RUM JUNGLE REHABILITATION PROJECT

Potential Impact of Climate Change on Rehabilitation Design

SLR Ref: 623.30135.00100 -R01
Version No: -v1.1
January 2022

Figure 21 1% AEP flood depth as a consequence of the climate change influencers

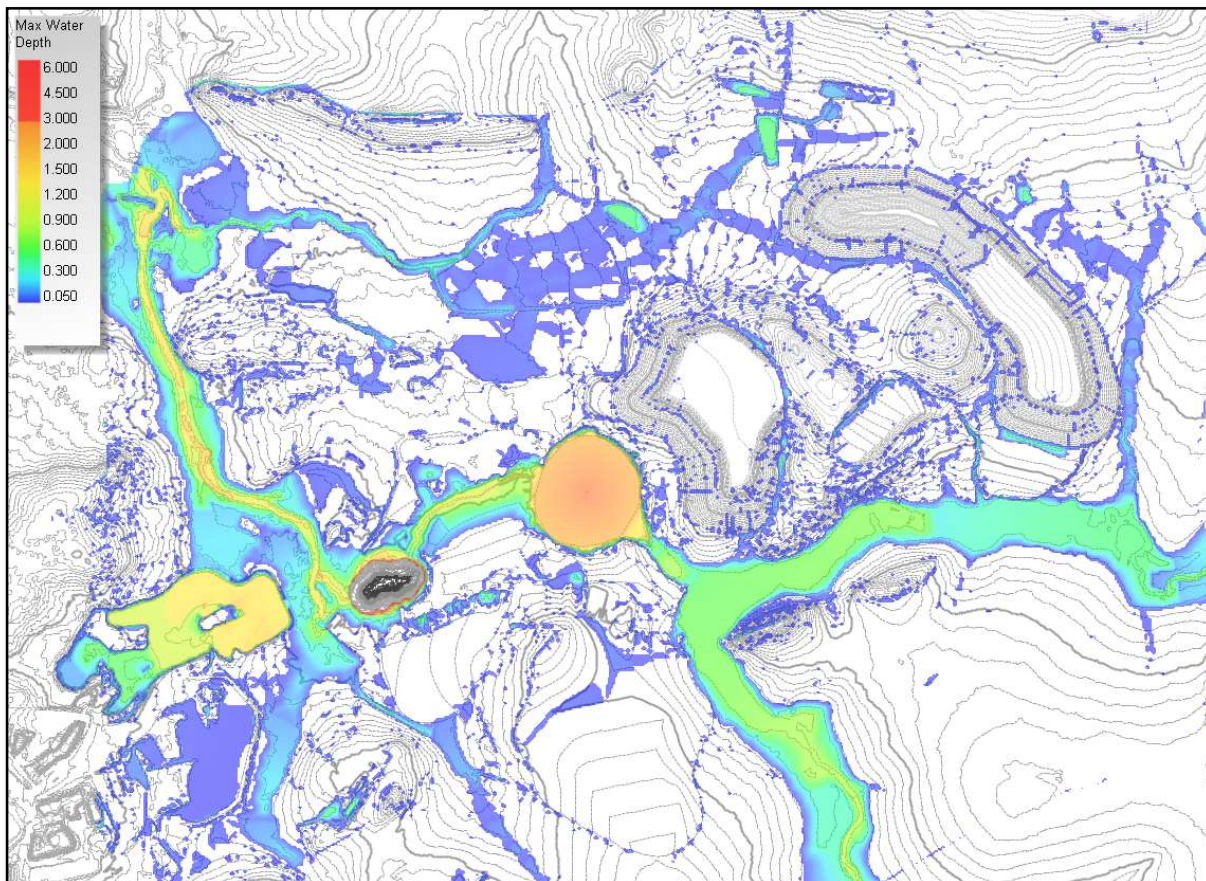
c) vi.	<i>The Department notes that flooding is likely to cause erosion of the waste storage facility and Main Pit capping layer material. Please provide a flooding sensitivity analysis that investigate the impacts of more extreme flooding than a 1 per cent AEP event (the currently modelled scenario)."</i>	<p>Modelling of climate change influencers indicates that the flood level increase over the site would vary between 50mm and 600mm. The greatest level increase would occur at the channel necking upstream of the entry to the Main Pit. The flow path between the Main and Intermediate Pits would increase by approximately 400mm with the remainder of the catchment 300mm and less.</p> <ul style="list-style-type: none"> Hydraulic modelling has confirmed that the climate influencers would increase flood levels within the EBFR and Fitch Creek flow paths between 50 and 600mm with the average increase approximately 350mm. The flood level increase would not exceed the defined channel and inundate the proposed waste storage facility (WSF) areas. The modified Main Diversion Channel will not be activated.

The flood level results due to the influencers are shown in **Figure 21**.

Flooding sensitivity to climate change influences is addressed in **Section 8.1.3** and shown in **Figure 21**.

Figure 26 Increase in velocity as a result of the climate change influencers

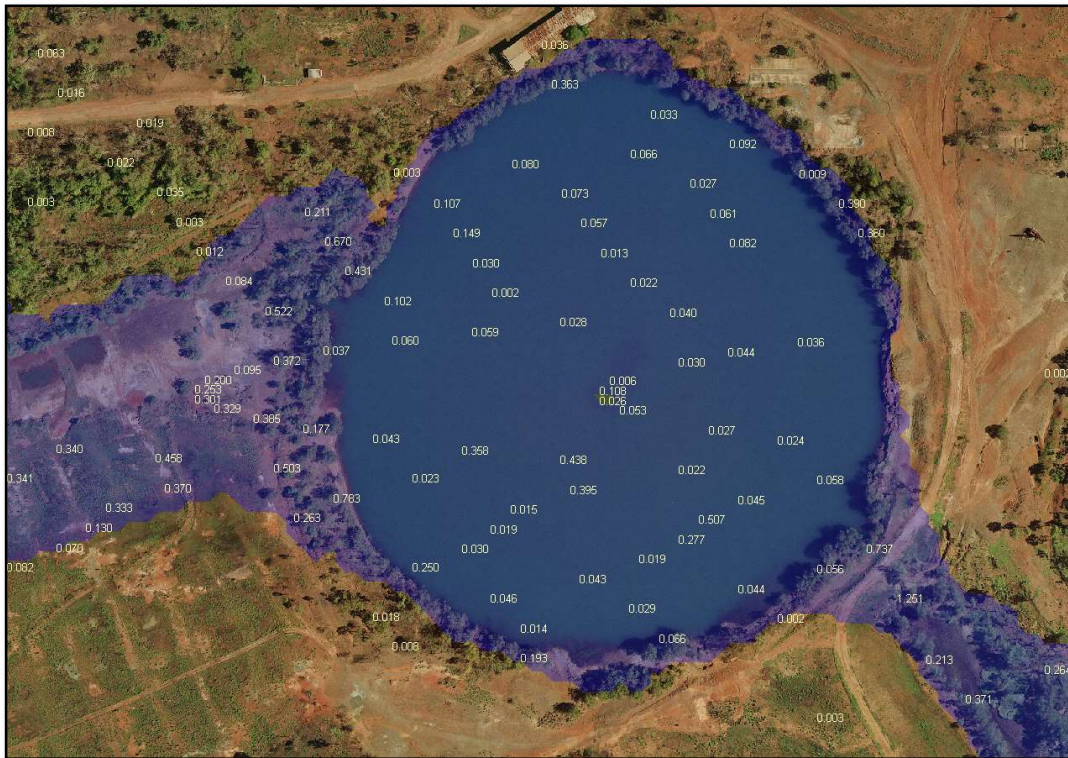
c) v.	and	
	Flowrates in the proposed diversion/realignment through the pit pathway, including the effects of modelled change in the intensity, frequency and duration of rainfall events.	<p>The impact on the rehabilitation design for the Main Pit is as follows:</p> <ul style="list-style-type: none"> • The climate change influencers could increase bed velocities by up to 0.6m/s at the entrance and exit to the Main Pit. • The climate change influencers could increase bed velocities by up to 0.2m/s in the direct flow path in the Main Pit between the inlet and outlet. • The climate change influencers will not change the bed velocities over the remainder of the Main Pit floor.

- ➔ The climate change influencers could increase bed velocities by up to 0.6m/s at the entrance and exit to the Main Pit.
- ➔ The climate change influencers could increase bed velocities by up to 0.2m/s in the direct flow path in the Main Pit between the inlet and outlet.
- ➔ The climate change influencers will not change the bed velocities over the remainder of the Main Pit floor.
